From: [Trang Nguyen](#)  
 To: [Trang Nguyen](#)  
 Subject: RE: exact location RE: Kelly Media LLC file number SES-REG-20181012-05460 Call Sign E200166  
 Date: Wednesday, January 29, 2020 1:31:49 PM  
 Attachments: [img00001.png](#)

This is in referenced to your pending application for C-Band Registration file number SES-REG-20181012-05460, Call Sign E200166, Cushing, OK.

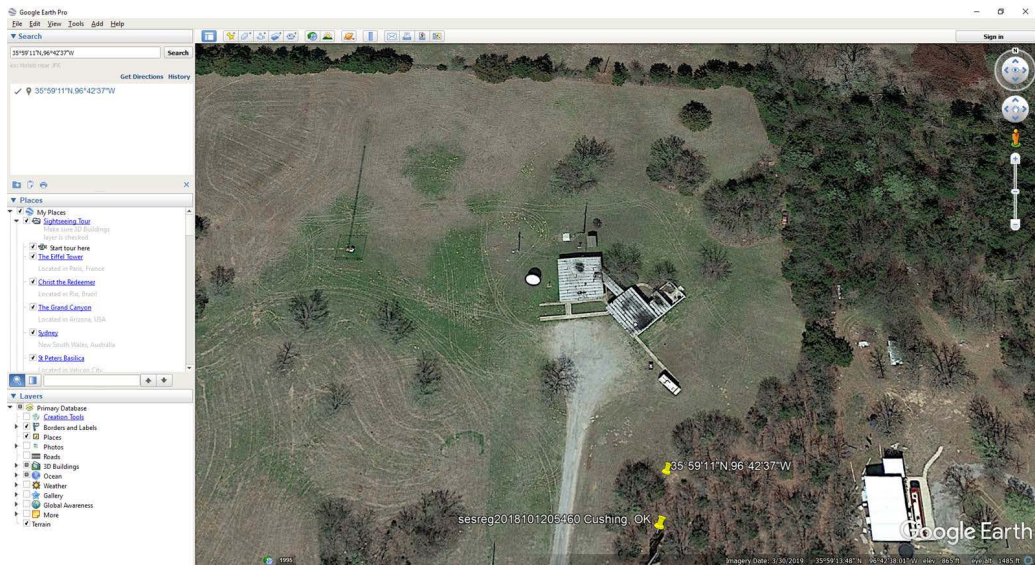
The screen shot below is from Google Earth which is showing where the dish KUSH antenna is ( 35° 59' 12.79\"N, 96° 42' 38.44\"W) . Please confirm if that is correct since the application listed the coordinates at a different location.

The correct coordinates are ( 35° 59' 12.81\"N, 96° 42' 38.44\"W). See the attached screenshot.  
 Norm
